**UNITED STATES OF AMERICA  
NUCLEAR REGULATORY COMMISSION  
BEFORE THE ATOMIC SAFETY AND LICENSING BOARD**

In the Matter of:	)	
	)	
FLORIDA POWER & LIGHT COMPANY	)	Docket No. 50-250-SLR
	)	Docket No. 50-251-SLR
(Turkey Point Nuclear Generating Station, Unit Nos. 3	)	
and 4)	)	June 24, 2019
	)

**EXPERT REPORT OF WILLIAM NUTTLE, PH.D, PEng (Ontario)**

Figure 1: Daily values of the components of the CCS water budget reported from FPL's monitoring program for the period September 2010 through November 2017. Upper panel: average salinity in CCS. Bottom panel: daily values of rainfall and water inputs from other sources.

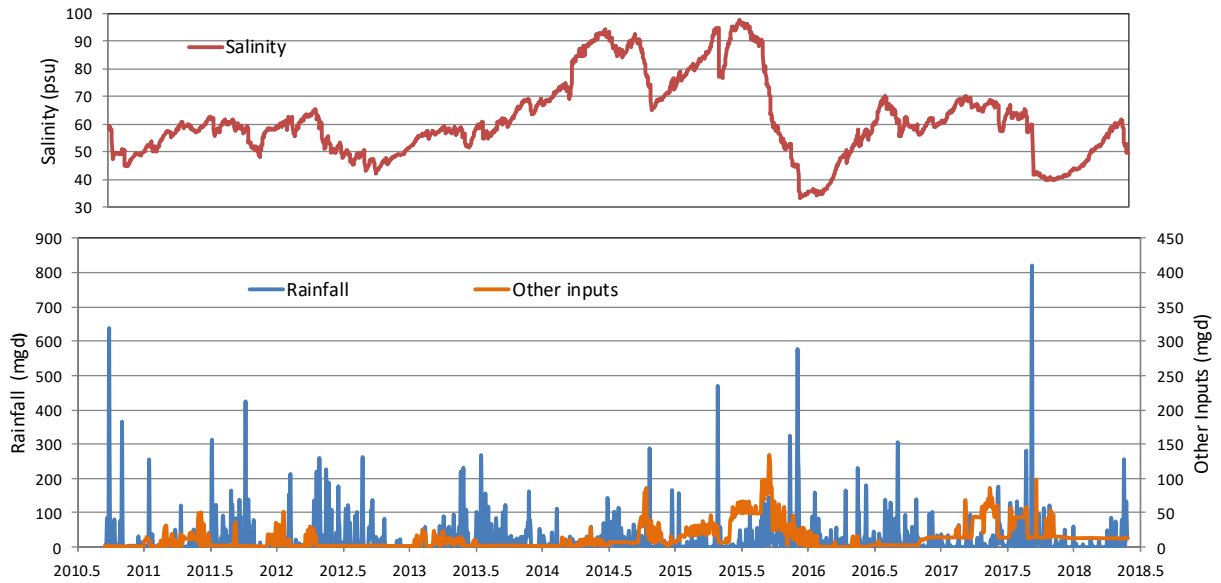
time: September 2010 through November 2015,<sup>1</sup> June 2015 through November 2016,<sup>2</sup> Jun 2016 through May 2017,<sup>3</sup> and June 2017 through May 2018,<sup>4</sup> Figure 1.

The reductions in salinity achieved from actually adding fresh water to the CCS have, so far, not been able to replicate the results of the model simulation. The freshening program of adding 14 mgd of Floridan water on a continuous basis began on November 28, 2016; however, water additions, using various amounts from a variety of other sources, for the purpose of reducing salinity were first made in response to a spike in salinity in 2014, Table 1. During the period beginning in 2014, in only one year has the reduction in salinity matched the results of the model. This occurred during calendar year 2015, when salinity dropped from about 70 psu on January 1 to about 35 psu at the end of December, Figure 1. However, the amount of additional water required to achieve this result was about double the prescribed 14 mgd, Table 1.
